NEW MEXICO OIL CONSERVATION DIVISION
- Engineering Bureau
1220 South St. Francis Drive Santa Fe, NM 87505

2010 SEP 17 1:15 PM Bran SWD # 1

ADMINISTRATIVE APPLICATION CHECKLIST

APPLICATION FOR AUTHORIZATION TO INJECT

RE-ENTRY & COMPLETION WELL DIAGRAM

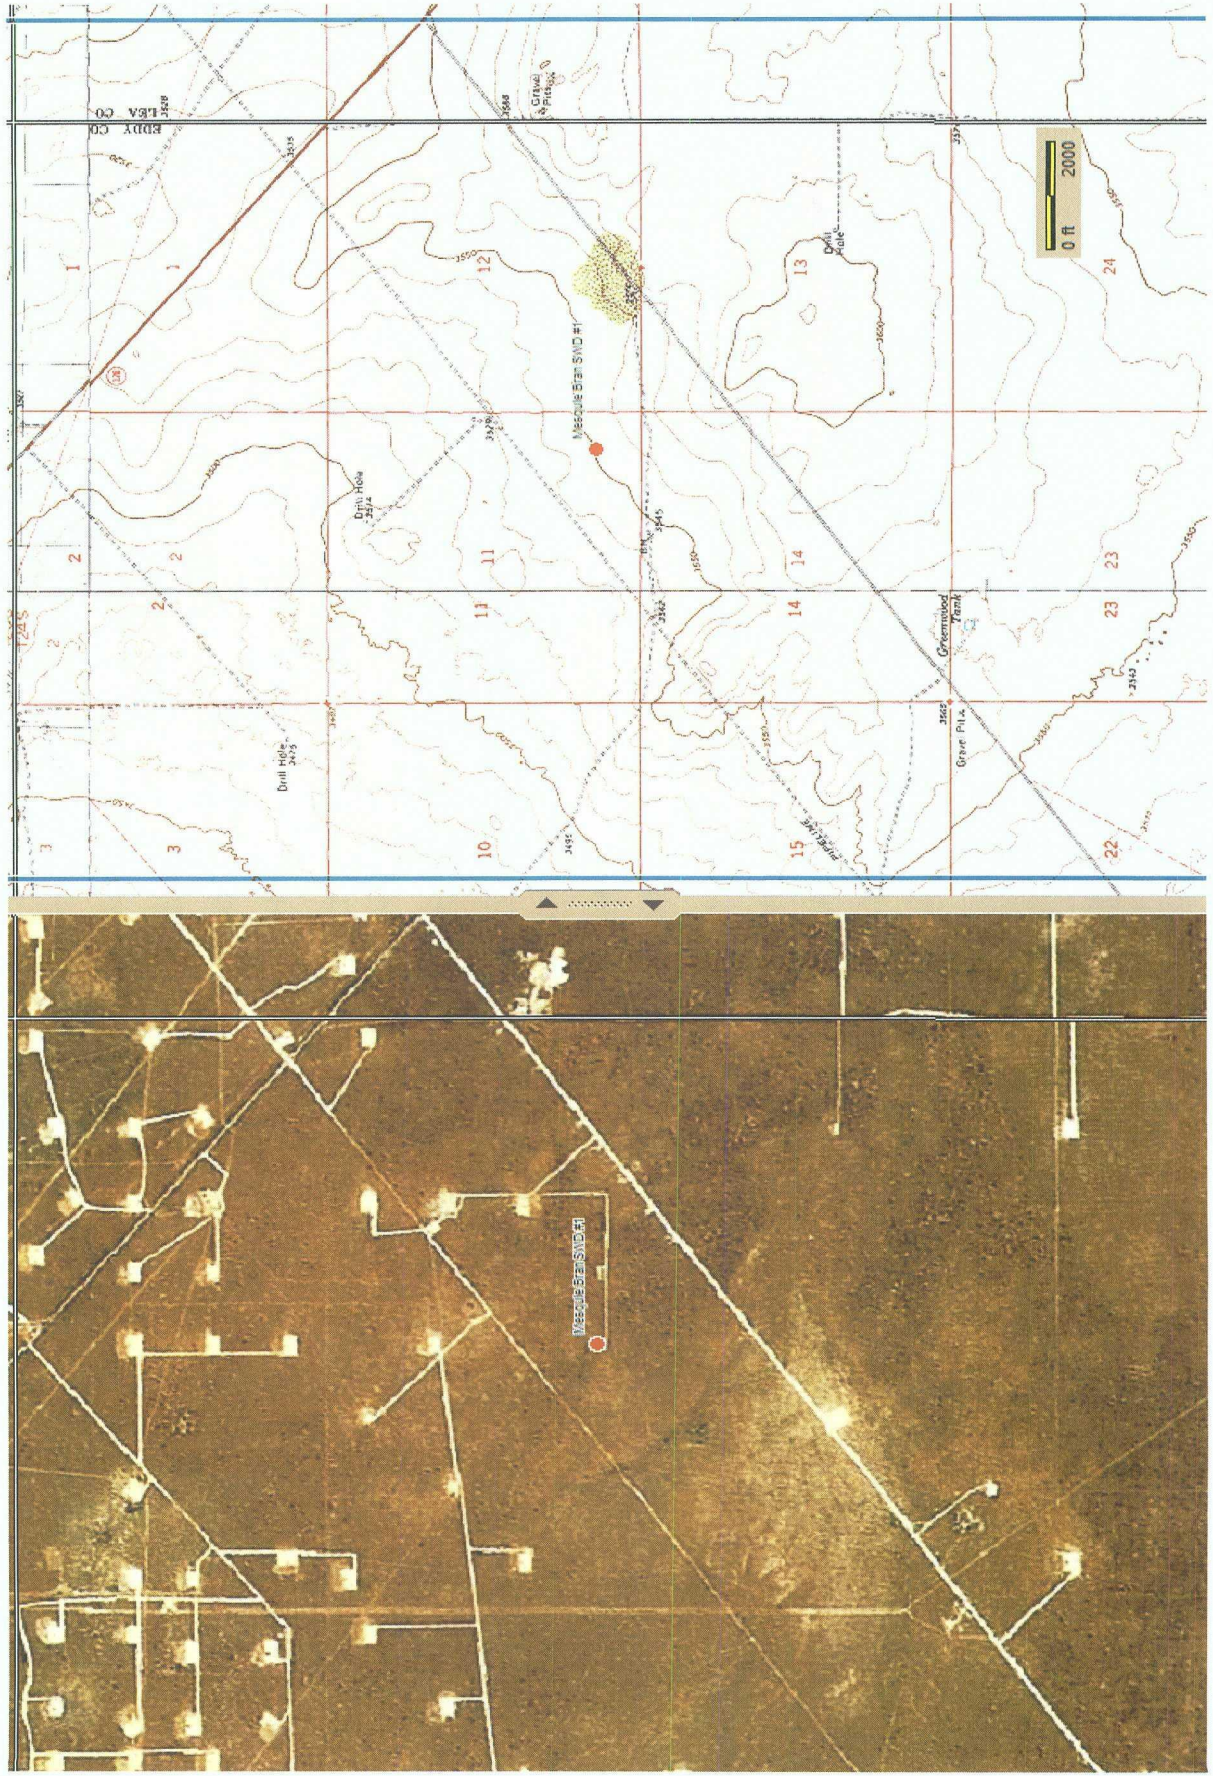
Mesquite SWD, Inc filed C-108 on the subject well and it was protested by Marbob. They have withdrawn their protest with the condition Mesquite cases down to 4850' and keep the depth @ 6794'. Mesquite is willing to accept those depths. We trust this meets with your approval. Thank you.

Marbob Energy will withdraw our objection to Mesquite converting this well to SWD if they will increase their proposed casing setting depth from 4525' to 4850' to cover up the upper Bell Canyon sand and keep the proposed TD of the well at 6794'. Please contact me at bcollins@marbob.com or 575-748-3303 if you have questions.

Intermediate casing (6") will be set at 4,850' as shown below. Top of Lamar Lime is at 4492'.

Size: 6"
Set @: 4850
Sxs cmt: Est 850
Circ: Yes
TOC: Surface
Hole Size: 7-7/8"

Drill-out cement 3970-4570'
Run 6" 18# J55 cement 2 stage to
circulate cement est 850 sxs
CO to 4800' test csg
